Sheet:	F.Cu F.Silk	
File: UPD-board.kicad_pcb	B.Cu B.Silk	
Title:		
Size: A4 Date:		Rev:
KiCad E.D.A. kicad 6.0.7-f9a2dced07~116~ubuntu20.04.1		ld: 1/1

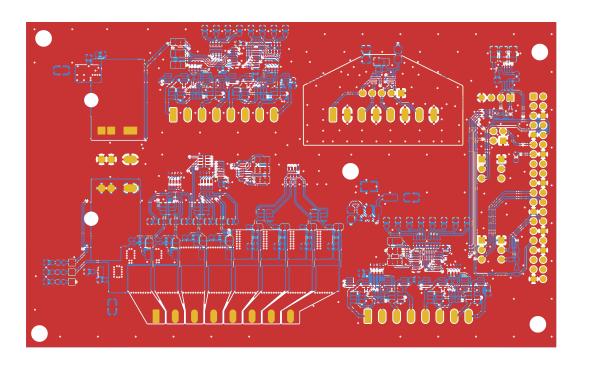
TODO:

Different analog connector Too many vias in high current traces? Different ground plane, need something special for signal ground?

Sheet:		F.Cu		-
File: UPD-bo	ard.kicad_pcb			D
Title:				
Size: A4	Date:		Rev:	
KiCad E.D.A. kicad 6.0.7-f9a2dced07~116~ubuntu20.04.1		ld: 1/1		
/,		Б.

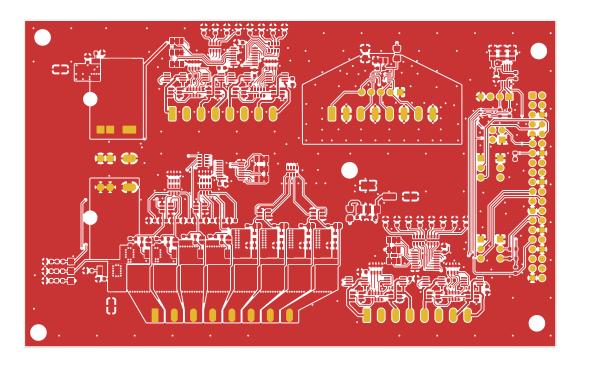
TODO:

Different analog connector Too many vias in high current traces? Different ground plane, need something special for signal ground?
